SUBJECT: AMENDMENT NO. 36 TO FACILITY OPERATING LICENSE NPF-73:
PRESSURE-TEMPERATURE LIMITS - CHANGE REQUEST 40 (TAC NO. 76890)

BEAVER VALLEY POWER STATION, UNIT NO. 2

Amendment No. 36
License No. NPF-73

SAFETY EVALUATION BY THE OFFICE OF NUCLEAR REACTOR REGULATION
RELATED TO AMENDMENT NO. 36 TO FACILITY OPERATING LICENSE NO. NPF-73

FIGURE 3.4-2 BEAVER VALLEY UNIT 2 REACTOR COOLANT SYSTEM HEATUP LIMITATIONS APPLICABLE FOR THE FIRST 10 EPFY

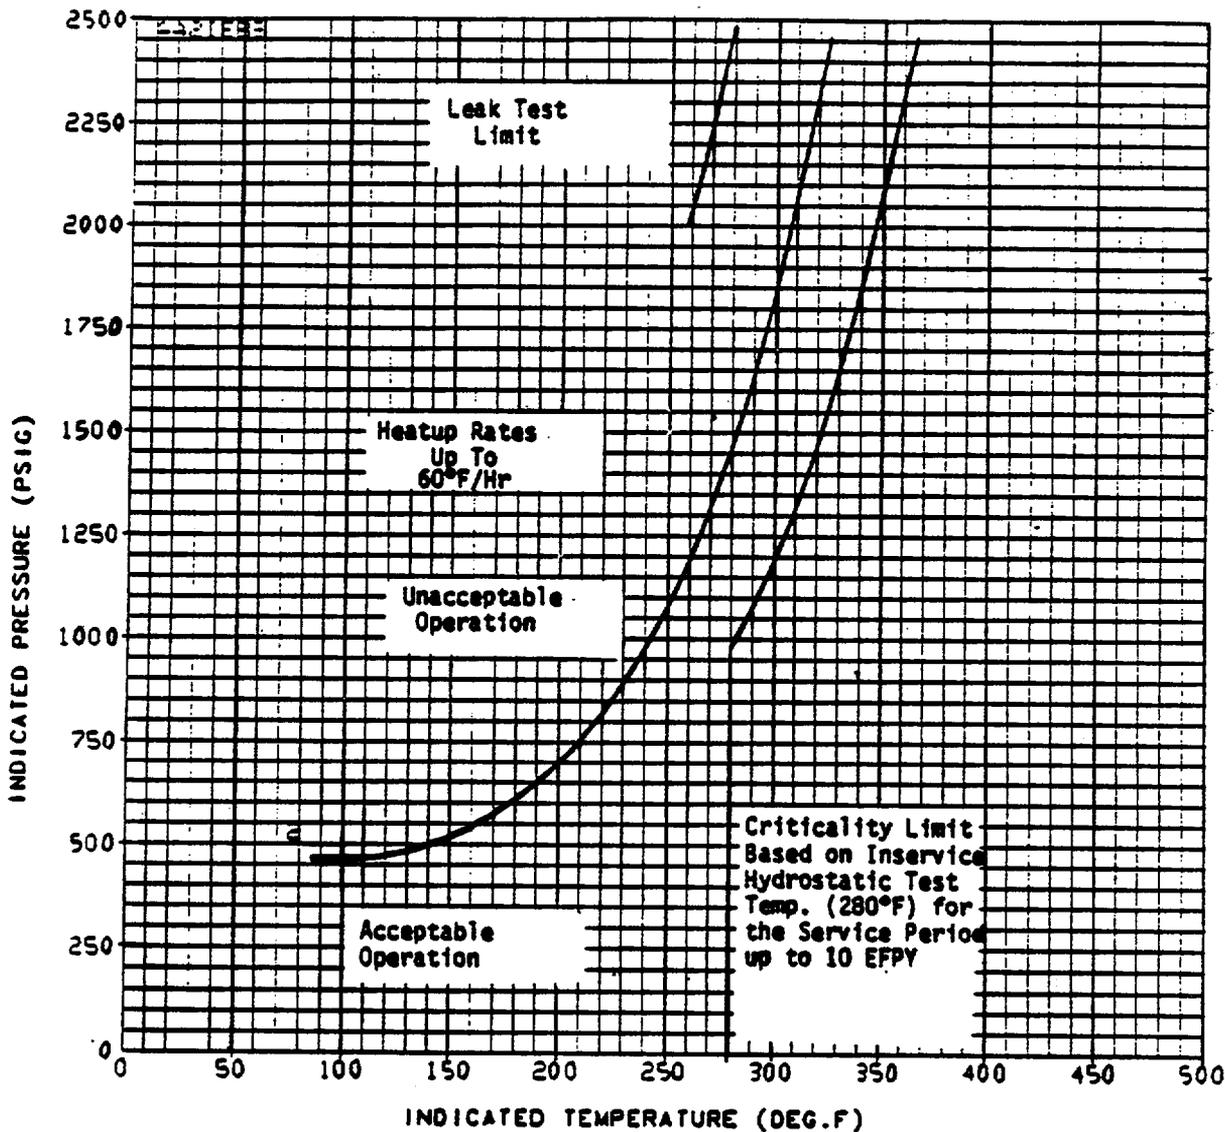
The amendment modifies the Appendix A Technical Specifications (TSs) for the reactor coolant system (RCS) heatup and cooldown curves. Specifically, the amendment incorporates revised Figures 3.4-2 and 3.4-3. These revised curves are applicable to 10 effective full-power years (EFPY), and have been developed consistent with the recommendations of Regulatory Guide (RG) 1.99 (Rev. 2).

For the limiting beltline material, plate B9004-1, we calculated the ART to be 140.4°F at 1/4T and 128.6°F at 3/4T. The staff used a neutron fluence of 1.22E19 n/cm² at 1/4T and 4.66E18 n/cm² at 3/4T.

Duquesne Light Company used the method in RG 1.99, Rev. 2, to calculate an ART of 140°F at 1/4T and 129°F at 3/4T for the same limiting metal. Substituting the ART of 140.4°F into equations in SRP 5.3.2, we verified that the proposed P-T limits for heatup, cooldown, and hydrotest meet the beltline material requirements in Appendix G of 10 CFR Part 50.

We find that the proposed P-T limits for the reactor coolant system for heatup, cooldown, leak test, and criticality are valid through 10 EFPY because the limits conform to the requirements of Appendices G and H of 10 CFR Part 50. Duquesne Light Company's submittal also satisfies Generic Letter 88-11 because the method in RG 1.99, Rev. 2, was used to calculate the ART. Hence, the proposed P-T limits as represented on revised Figures 3.4-2 and 3.4-3 may be incorporated into the BVPS-2 Technical Specifications.

MATERIAL PROPERTY BASIS

CONTROLLING MATERIAL: INTERMEDIATE SHELL PLATE B9004-1

INITIAL RT_{NDT}: 60°F

RT_{NDT} AFTER 10 EPFY: 1/4T, 140°F
 3/4T, 129°F

CURVES APPLICABLE FOR HEATUP RATES UP TO 60°F/HR FOR THE SERVICE PERIOD UP TO 10 EPFY. CONTAINS MARGIN OF 10°F AND 60 PSIG FOR POSSIBLE INSTRUMENT ERRORS.
